IMPORTANT SAFETY RECALL**P07 / NHTSA 14V-100**

Chrysler has decided that some **2014 model year RAM 5500 trucks** fail to conform to Federal Motor Vehicle Safety Standard (FMVSS) No. 567 – Certification.

Figure 1 – Four Door Model Shown

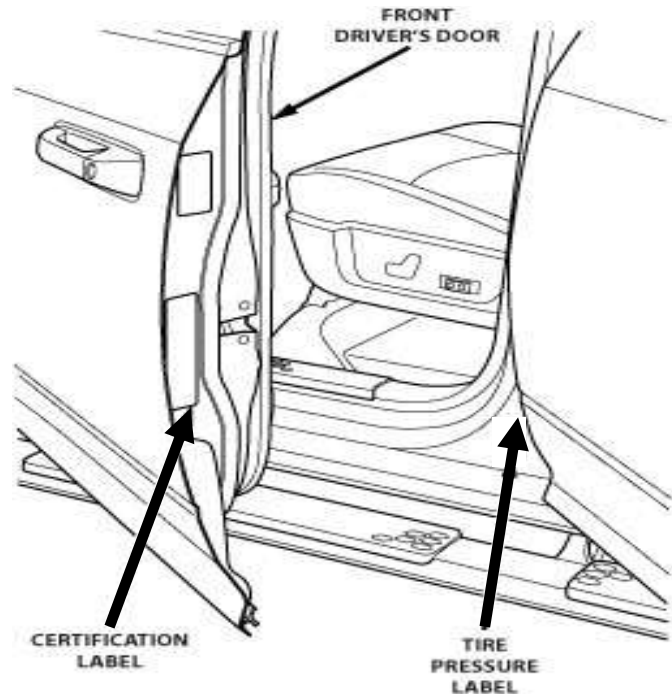
The problem is... **The Certification and Supplemental Tire Pressure Information label on your truck fail to conform to the requirements of Federal Motor Vehicle Safety Standard (FMVSS) No. 567, “Certification”. The labels contain incorrect vehicle weight rating and incorrect payload value on the supplemental tire pressure label. This can cause improper loading of the vehicle and cause a crash without warning.**

What you must do to ensure your safety... ➤ **We ask that you apply the enclosed Certification label and Supplemental Tire Pressure Information label so that they cover the existing labels as described on the reverse side of this letter.**

1. Open the driver's door and locate the Certification label on the driver's door as shown in Figure 1.
2. Clean the existing Certification label with alcohol / glass cleaner or equivalent and a soft cloth to remove any dirt, oil residue or grease.
3. Remove the enclosed Certification label from its paper backing and carefully install it over the existing Certification label (Figure 1). Firmly press and smooth the label to the surface of the existing Certification label to ensure good adhesion.
4. Locate the Supplemental Tire Pressure Information label on the driver side B-post above the door striker as shown in Figure 1.

5. Clean the existing Supplemental Tire Pressure Information label with alcohol / glass cleaner or equivalent and a soft cloth to remove any dirt, oil residue or grease.
6. Remove the Supplemental Tire Pressure Information label from its paper backing and carefully install it over the existing label (Figure 1). Firmly press and smooth the label to the surface of the existing Supplemental Tire Pressure Information label to ensure good adhesion.
7. Fleet companies requiring Incomplete Vehicle Documentation (IVD) labels are required to call 1-866-726-4636 to request the labels. Please provide a name and address when requesting a IVD label. The labels will be mailed overnight.
